The Bethlehem City Environmental Advisory Council appreciates the opportunity to comment on the revised Master Plan for Tower Place development, 1170 8th Avenue. Our recommendations are in support of Bethlehem City's Climate Action Plan, which aims to reduce our carbon footprint, increase sustainability and utilize alternative energy sources.

The EAC offers the following comments and recommendations based on the revised 2023 Master Plan.

Potential trail connections around Martin Tower site (CAT concept)

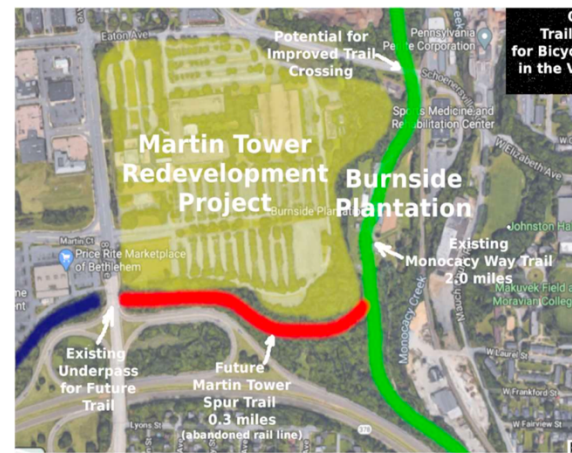
- In their letter of April 2021, the Coalition for Appropriate Transportation (CAT) diagramed a potential spur to connect the north-south D&L Trail to an east-west corridor from Burnside Plantation to Allentown. Please see the explanation and diagram excerpted from their letter below, which the EAC supports.

While a 2+ mile rail trail might seem ambitious out of the gate, a starting point with this project should be to connect the Monocacy Way trail to 8th Avenue, a 0.3 mile long section that follows the southern border of the Martin Tower project. (shown in red as Future Martin Tower Spur Trail" in the image to the right)
